TECHNICAL EVALUATION REPORT
FOR THE RENEWAL OF
SOURCE MATERIALS LICENSE SUB-526
FOR
HONEYWELL METROPOLIS WORKS
UF6 CONVERSION PLANT
METROPOLIS, ILLINOIS
DOCKET 40-3392
May 11, 2007

Figure 3 Process Description

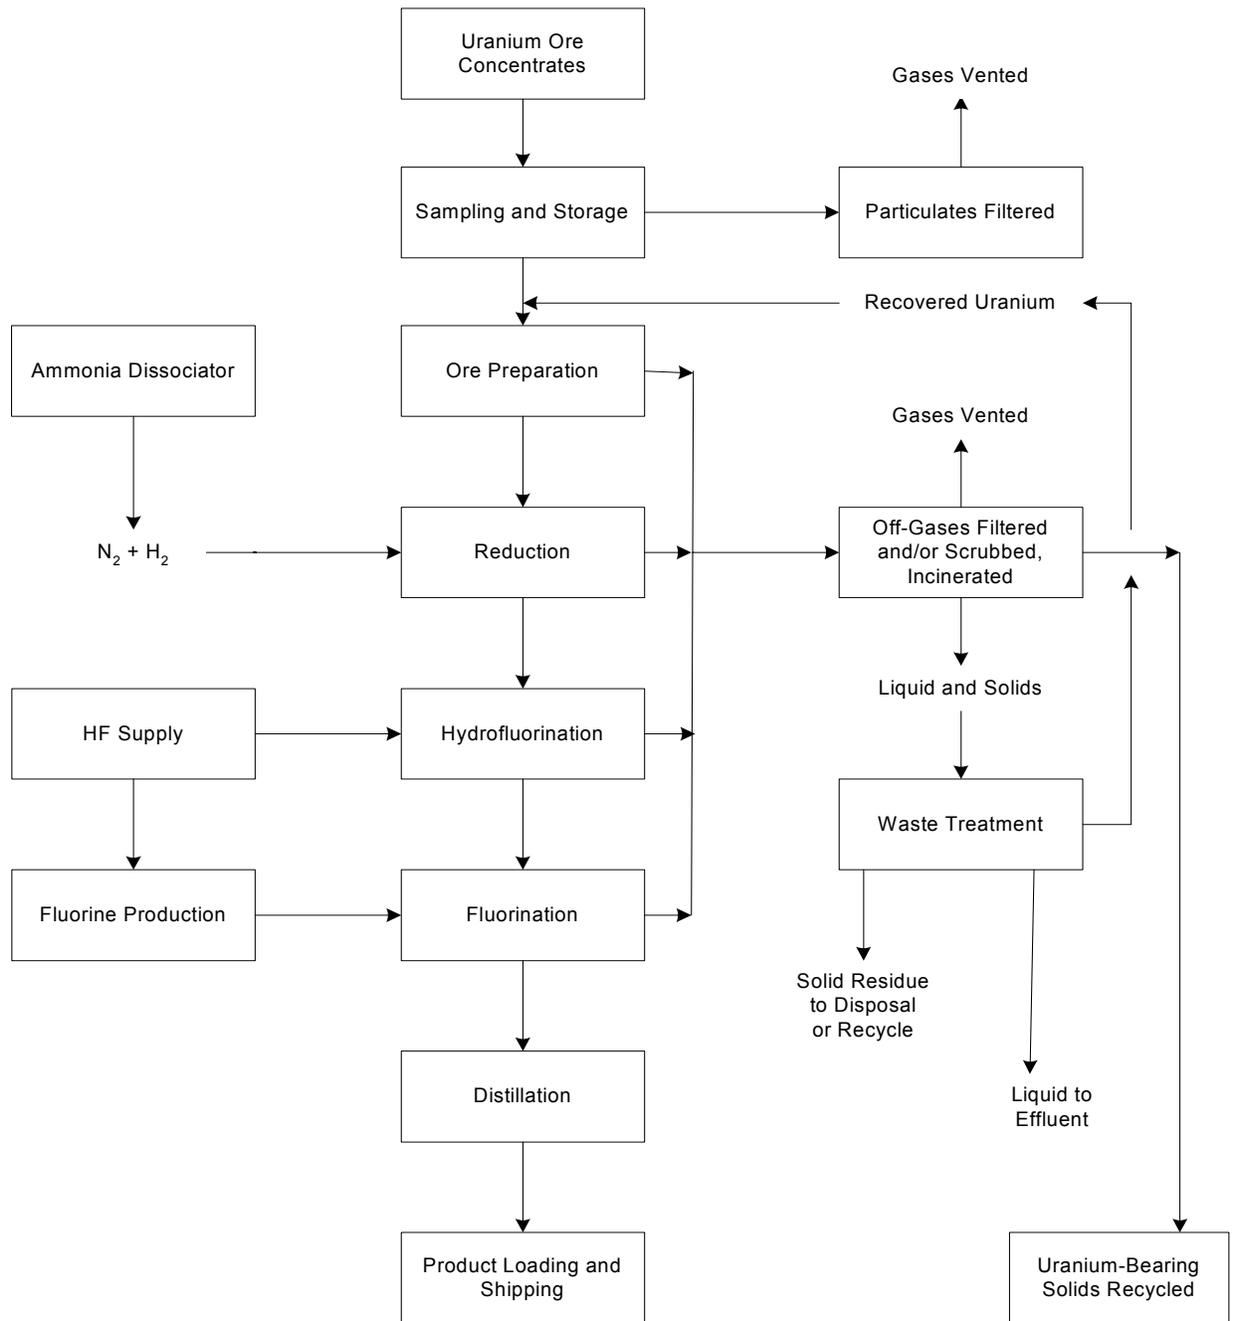
As part of the license renewal review, members of the NRC review team visited the MTW site. The site visit was to ensure that the written descriptions of the MTW matched the actual plant layout. Additionally, the process descriptions provided by the licensee were compared to the operating MTW.

The NRC staff found that the description of the proposed process operations presented in the renewal application was sufficiently detailed to enable a knowledgeable reader to comprehend the intended processes. The associated conditions of operations and the specific location of each process within the MTW were verified to be substantially correct. The process description is therefore acceptable.
